**DATE:** 2.17.2017  
**TO:** ProTrak  
**FROM:** Bill McDow  
Transportation Planning

■ **LAW OFFICE OF JASON VAUGHN [TRC Plan Review]**

☞ Initial Review Note ☞

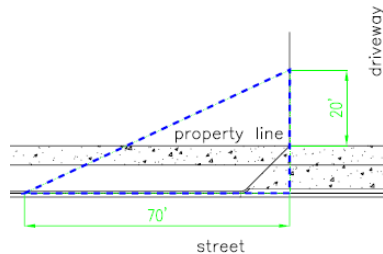
1. Traffic Engineering's stance on sites that interconnect along a major thoroughfare is that the combined frontage must meet all driveway spacing requirements per the City's technical standards.
2. Maximum allowed driveways along major thoroughfares is 1/600 lf of continuous frontage plus 1/every 300 additional lf or portion thereof as measured at the property line. [\[7-13 #b CofW Tech Stds\]](#)
3. Shared driveways are permitted in the Residential Office Zoning district. This type of one-way driveway is not typically allowed by NCDOT. Where multiple driveways are allowed along major thoroughfares they must be separated by 250' as measured along the curb line.

4. Show driveways for adjacent lots and lots across the street.
5. For this driveway to meet NCDOT and City Technical Standards, one entrance should be closed. Note which existing driveways will be closed. Extend the curb along these driveways and restore the verge area to match the existing/proposed.
6. Driveways shall be City-standard ramp-type driveways. Show appropriate City standard detail(s) on plan. [\[Chapter VII ,Detail SD 8-02 \(curb\) CofWTSSM\]](#)
7. Show proposed driveway centerline elevations at both the front and the back of each concrete driveway apron, at the curb line, property line & points at 26' and 52' behind the property line. [\[Chapter VII, C\(1\)\(a\)\(2\)12 CofWTSSM\]](#)
8. Dimension driveway widths and tapers. [\[Sec.18-529 CofW LDC\]](#)

9. The minimum two-lane driveway width is 23'. [\[7-9 CofW Tech Stds\]](#)
10. Provide a public 5' sidewalk along the Oleander Drive frontage.
11. Provide a sidewalk connection between the site and the public sidewalk.
12. Provide sidewalk detail SD 3-10 on the plan.
13. Show all adjacent traffic signs and pavement markings on the plan. [\[Sec. 18-529\(b\)\(2\) CofW LDC\]](#)
14. Show any traffic signal facilities and equipment in front of the development. Contact Traffic Engineering at 341-7888 for help in identifying these.
15. Show and apply the City's 20'x70' sight distance triangle at each driveway on the site plan and landscaping plan. [\[Sec.18-529\(c\)\(3\)CofW LDC\]](#) Add a note indicating that all proposed vegetation within sight triangles shall not interfere with clear visual sight lines from 30"-10'. [\[Sec.18-566 CofW LDC\]](#)
